In the Matter of)	
)	Docket 50-344
PORTLAND GENERAL ELECTRIC COMPANY,)	
et al)	(Control Building Proceeding)
)	
(Trojan Nuclear Plant))

I hereby certify that on July 10, 1979, Licensee's letter to the Director of Nuclear Reactor Regulation dated July 10, 1979 and an attachment entitled "Request for Additional Information, Trojan Nuclear Plant, Proposed Control Building Design", have been served upon the persons listed below by depositing copies thereof in the United States mail with proper postage affixed for first class mail.

Trojan Nuclear Plant
Docket 50-344
License NPF-1

Enclosed are the answers prepared by Bechtel Power Corporation to the remaining five questions from your letter of May 18, 1979. This submittal answers the last of the formal questions posed by your staff. A revision to PGE-1020 covering updated information will be issued shortly.

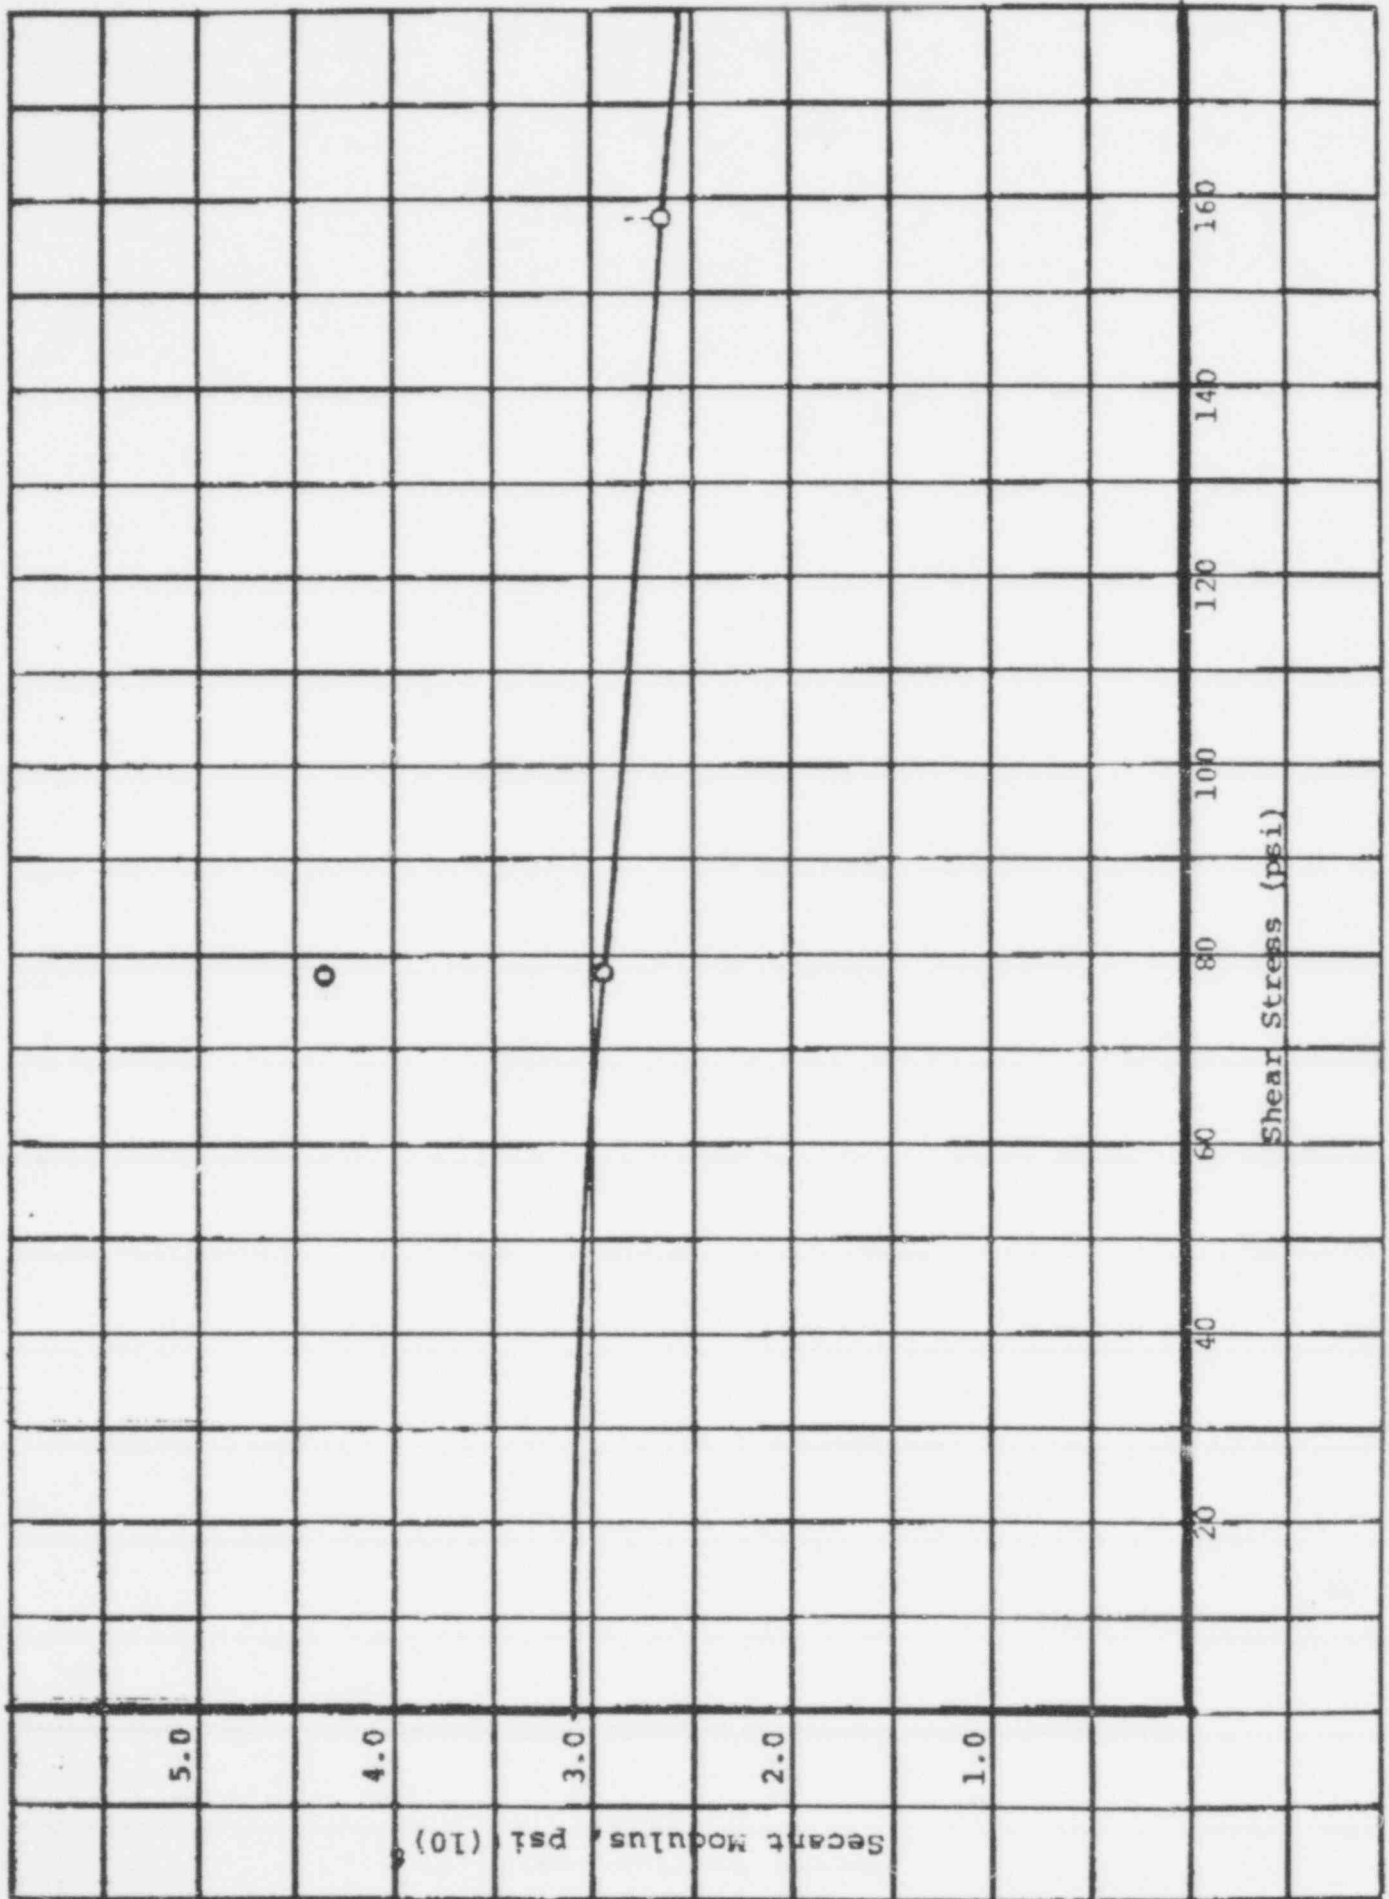
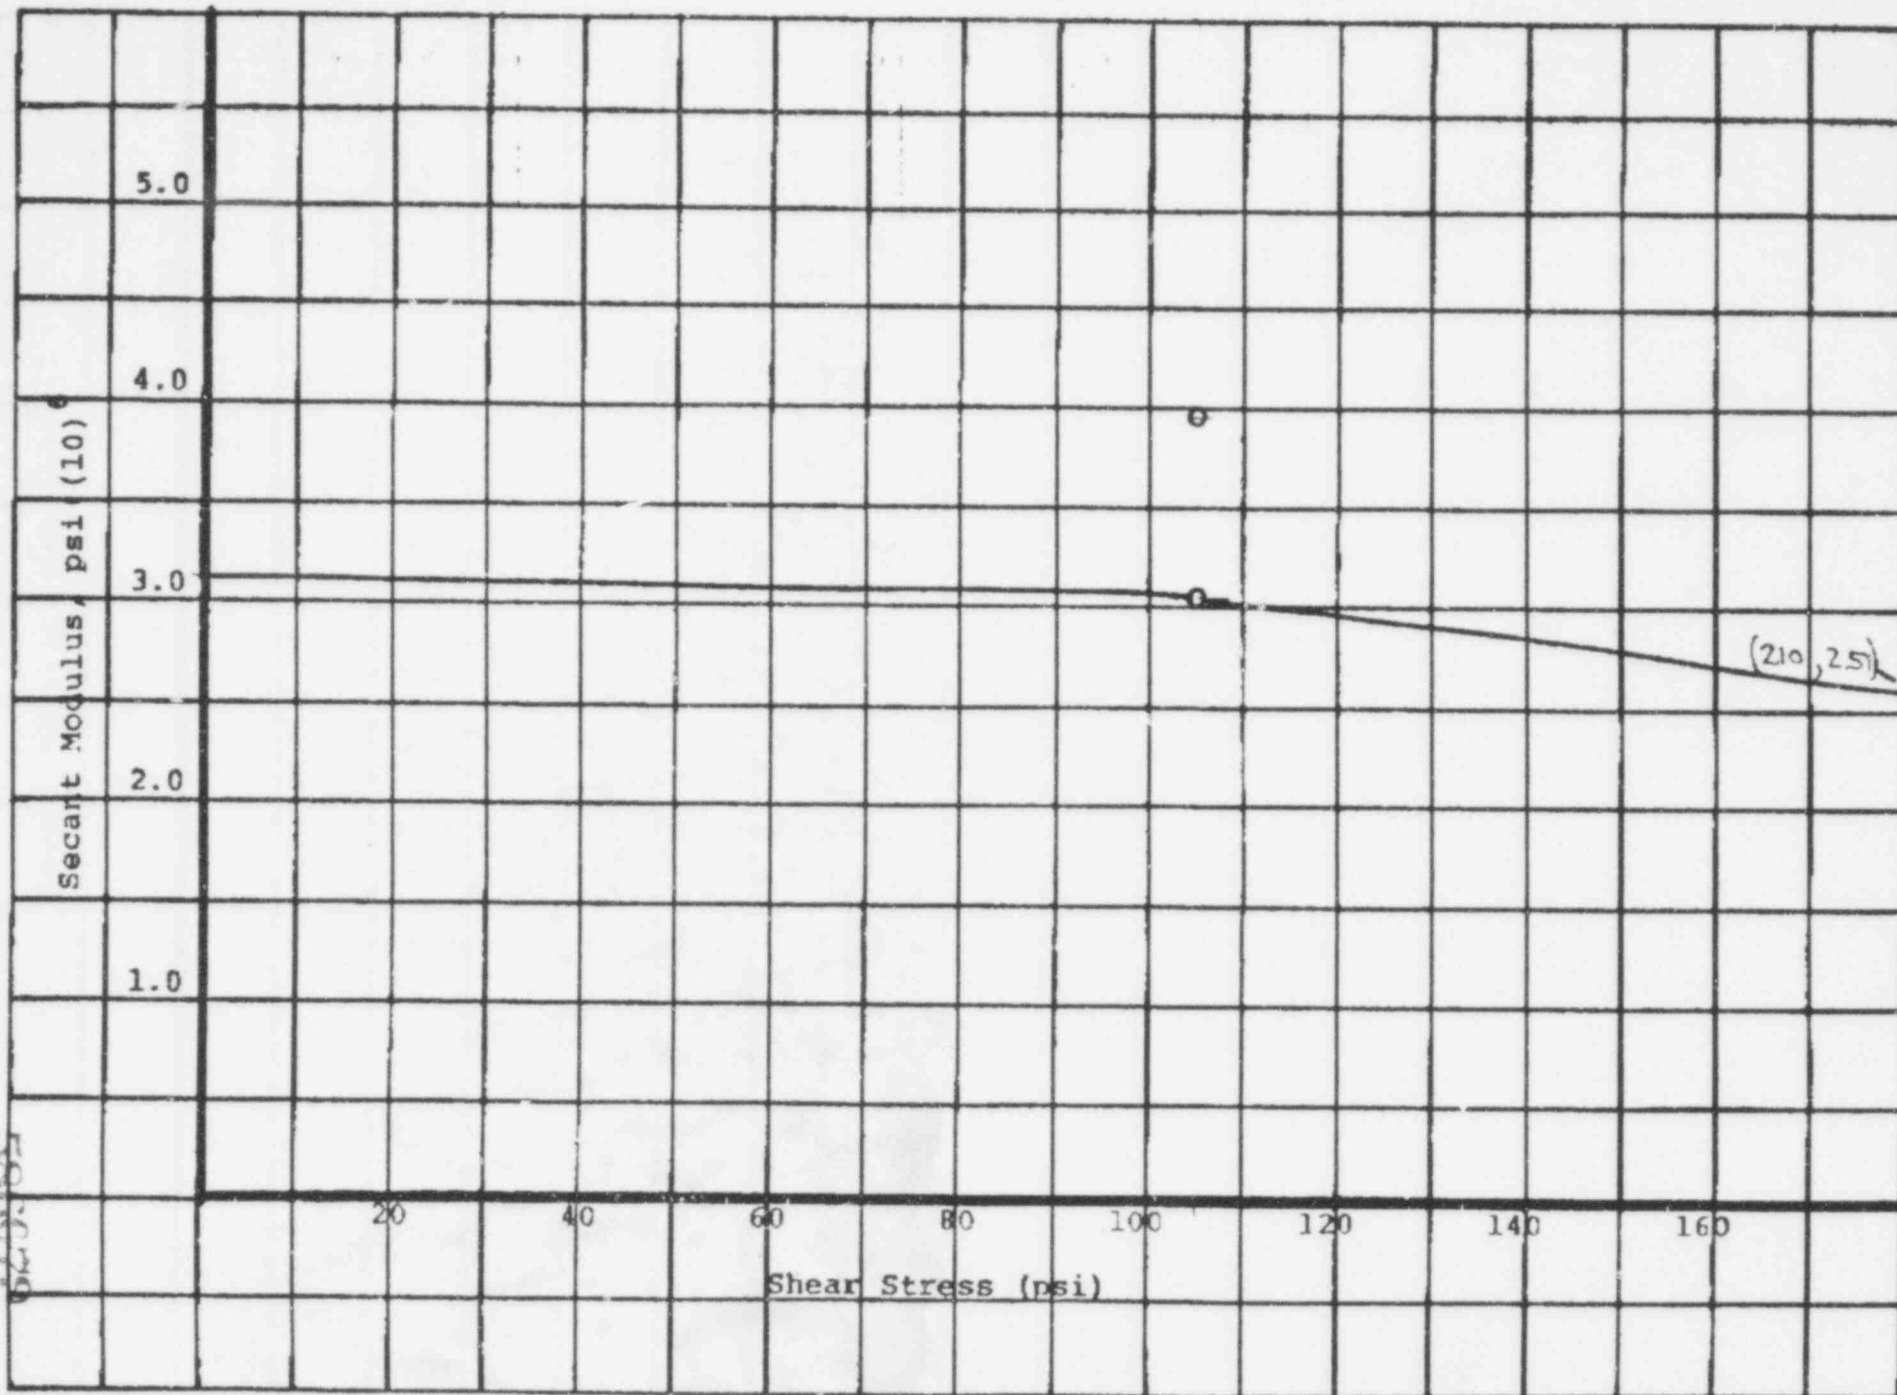
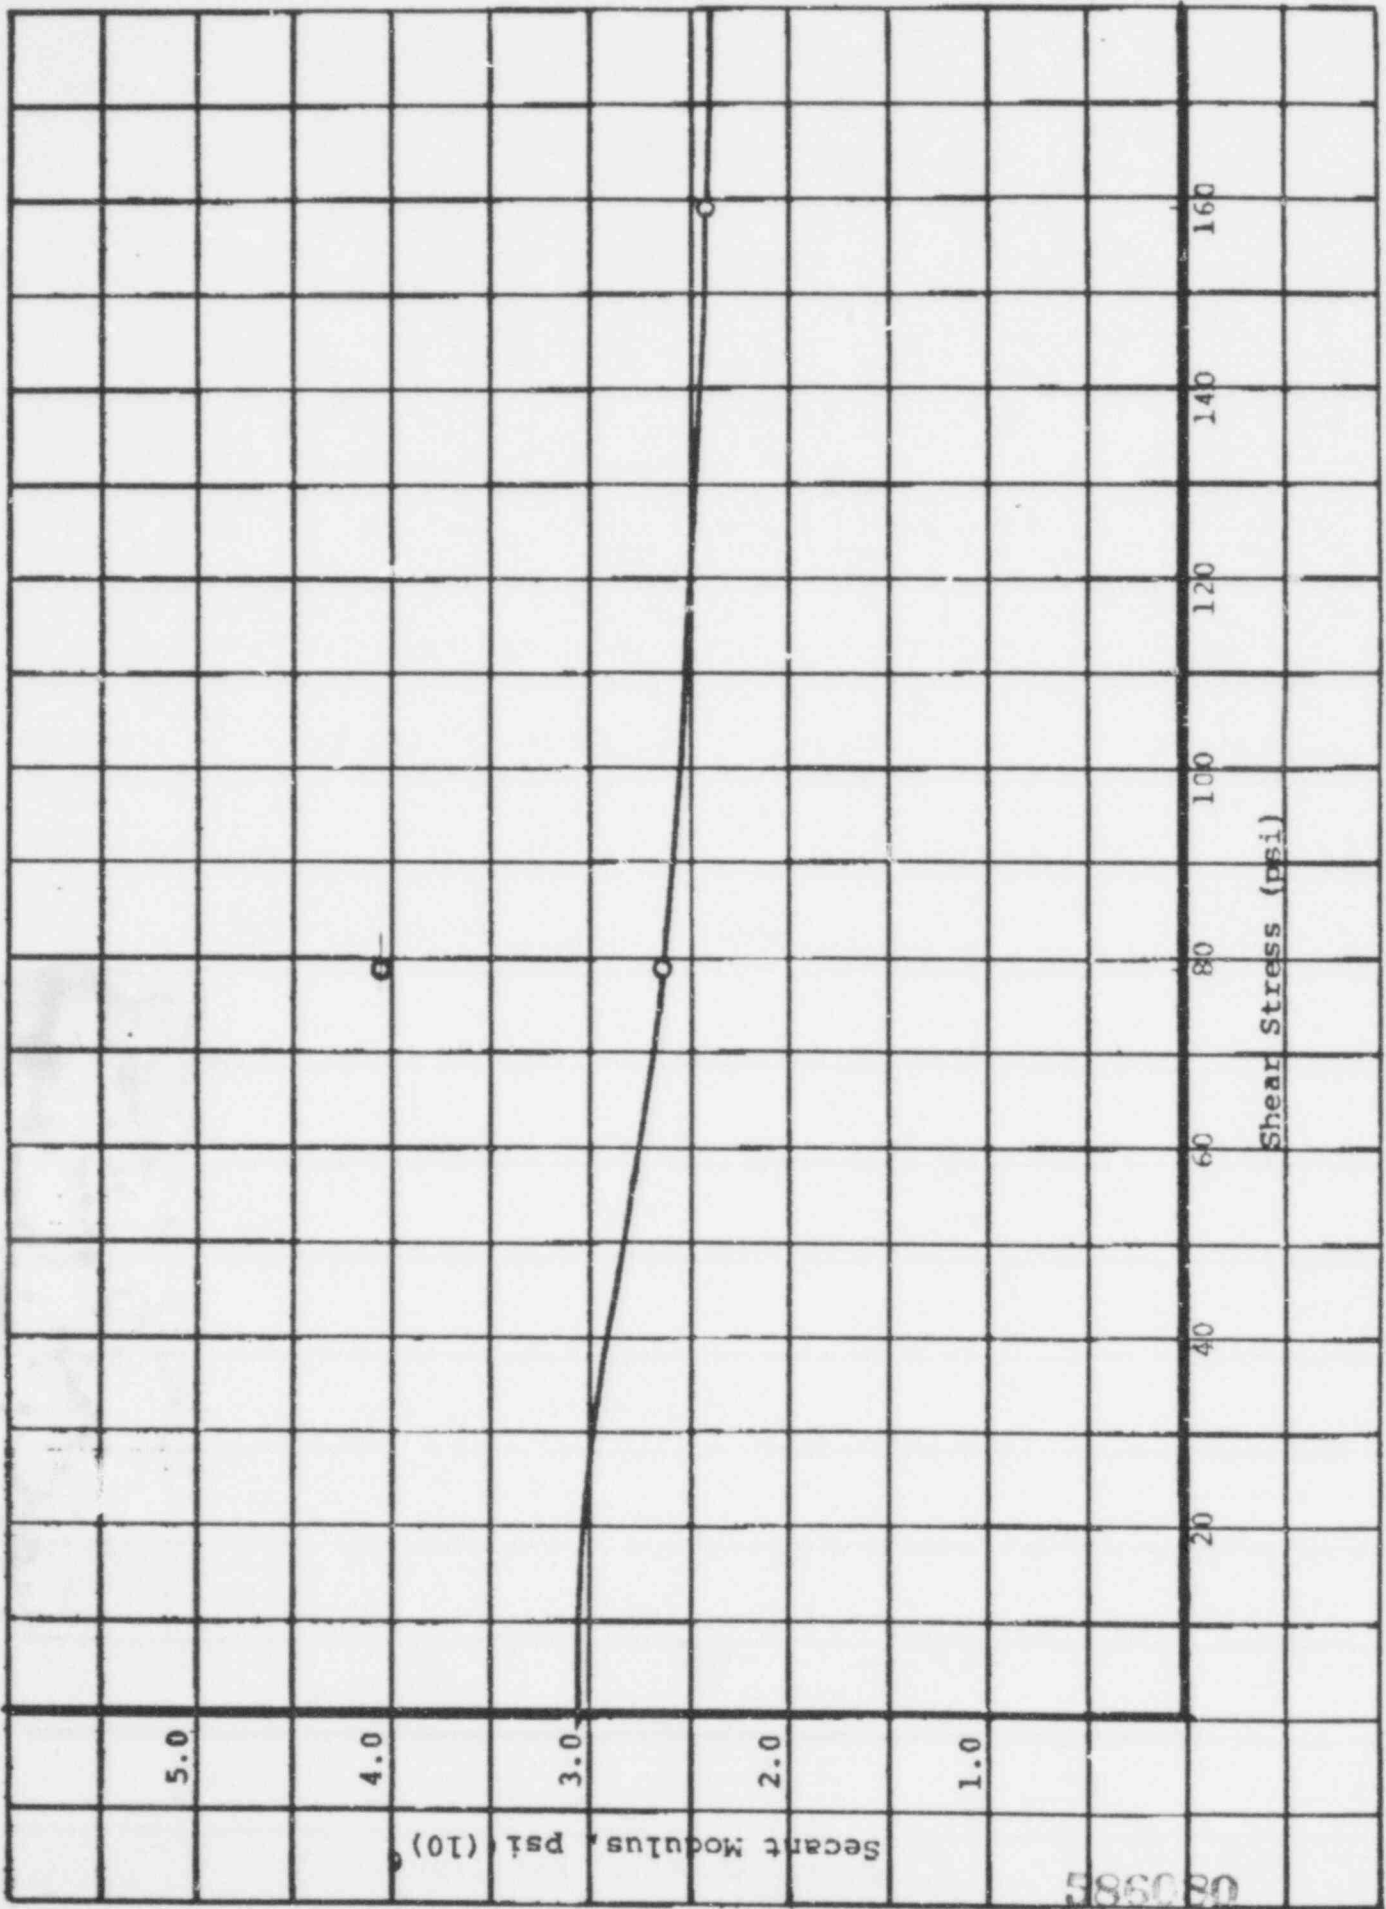
Provide the secant modulus derived for each of the test specimens vs. stress level; a comparison of the experimental initial elastic modulus for the test specimens vs. that calculated using the formula in Section 2.2.1.3.2 of Appendix B; the error bands, and their deviation, for the curves representing stiffness reduction as a function of stress level; and the stresses in each of the walls resulting from incorporation of the stiffness reduction factors in the STARDYNE model along with the associated stiffness reduction factors assumed in the analysis.

The secant modulus vs. shear stress for the test specimens is shown in Figures 46-1 through 46-20. A comparison between the experimental initial elastic modulus and that calculated using the formula in Section 2.2.1.3.2 of PGE-1020, Appendix B cannot be made since the initial modulus cannot be determined experimentally. The instrumentation was not sufficiently sensitive to measure the small deflections required for the calculation. Deflections need to be measured reliably to the nearest .0002 inch at the early stages of deformation. During this stage, the test specimen and load frame is settling in, play in instrumentation is being taken up, etc. Care was taken to minimize these effects but all could not be completely eliminated since the movements being considered are between 1 and 10 times smaller than the thickness of this paper. Some difficulty was even encountered at the first load step but for the other load steps the deflections were

large enough so that effects were not important. As shown in Figures 46-1 to 46-20, there are in general two data points at the first load step. The top part is obtained from the average deflections recorded on each side of the specimen and the other is obtained from the most active dial gauge. The initial modulus used in the plot was calculated using the equation in PGE-1020, Appendix B. An error analysis of the data could not be made since there are not enough specimens with duplicate conditions to provide sufficient data base. The effect of variation is considered in the broadening of the response spectra.
